Access Compliance Report

Public Rights-of-Way

(Curb Ramps)

Intersection ID: 28375	Main Street: CORNWALLIS_HALL_DR	Cross Street: WHEATFIELD_RD	Location: NW
ADA ID: 5A8812ADE7B4	Ramp Type: PerpDiag	Initial Pass/Fail: Fail	Overall Compliance: No
Severity Score: 13.75			
Codes/Mitigation Info/Possible Solution		Field Measurements/Component Compliance

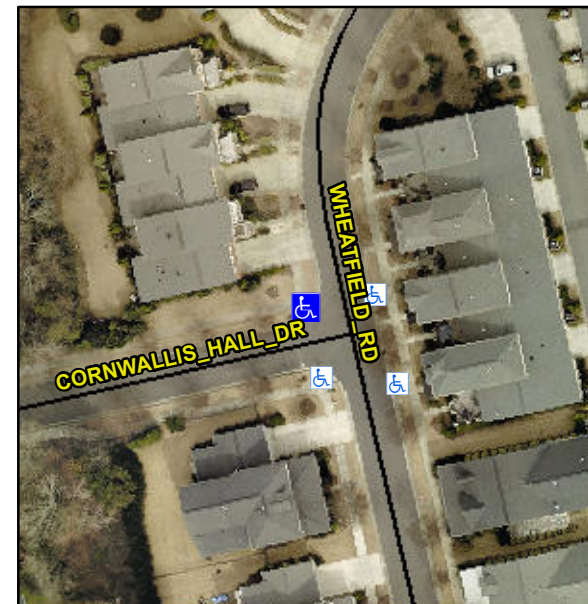
Not Found, R304.2.2, R304.5.3

Compliance	Description	Data	Compliance	Description	Data
N/A	Ramp Length (in)	71.0	No	Ramp Slope (%)	10.9
Yes	Ramp Width (in)	48.0	No	Ramp XSlope (%)	2.1
N/A	Flare Type LT	N/A	N/A	Flare Type RT	N/A
N/A	Flare Slope LT (%)	N/A	N/A	Flare Slope RT (%)	N/A
N/A	Flare Traversable LT?	N/A	N/A	Flare Traversable RT?	N/A
N/A	Landing Length (in)	N/A	N/A	DWS Provided?	N/A
N/A	Landing Width (in)	N/A	N/A	DWS Contrast?	N/A
N/A	Landing Slope (%)	N/A	N/A	DWS Length (in)	N/A
N/A	Landing X Slope (%)	N/A	N/A	DWS Full Width?	N/A
N/A	Landing Curb? (Y/N)	N/A	N/A	DWS Offset (in)	N/A
N/A	Shared Landing?	N/A			
N/A	Gutter Ponding?	N/A	N/A	Gutter Slope (%)	N/A
N/A	Gutter Lip Ht (in)	N/A	N/A	Gutter X Slope (%)	N/A
N/A	Painted X Walk1?	No	N/A	Painted X Walk2?	No
	X Walk 1 Direction	To S		X Walk 2 Direction	To E
N/A	X Walk 1 Width (in)	N/A	N/A	X Walk 2 Width (in)	N/A
	X Walk 1 Slope (%)	1.9		X Walk 2 Slope (%)	3.2
	X Walk 1 X Slope (%)	2.2		X Walk 2 X Slope (%)	0.2

Remove & Replace Curb Ramp With Two New Directional Ramps or Equivalent.
